Product Change Notification / ALAN-03HTZP673

CCB 4993 Final Notice: Qualification of 3280 die attach material and new lead frame design for selected products available in 8L SOIC package assembled at MMT assembly site.

CCB 4993
Pre and Post Change Summary
PCN# ALAN-03HTZP673

Pre and Post Change Summary

Pre Change

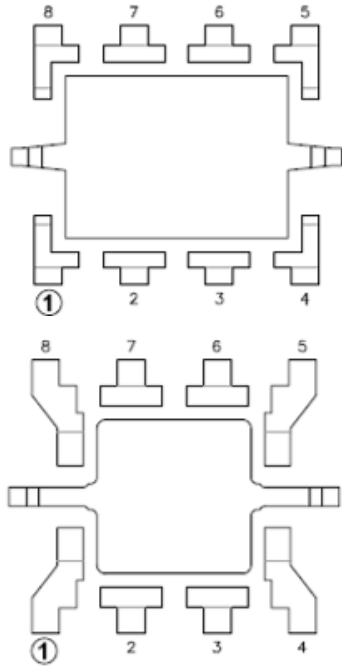
Lead-lock

No

Post Change

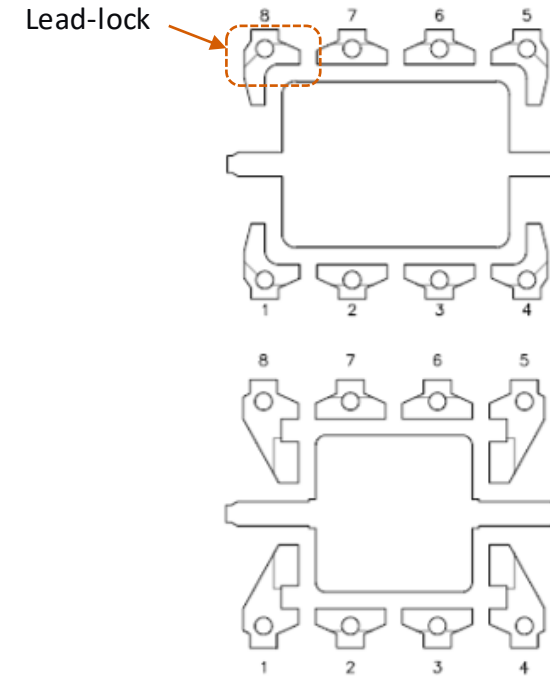
Lead-lock

Yes

Note: Mold compound materials fills the leadlockhole, which provides improved protection against moisture penetration along the edge of the leads (pins) of the package.
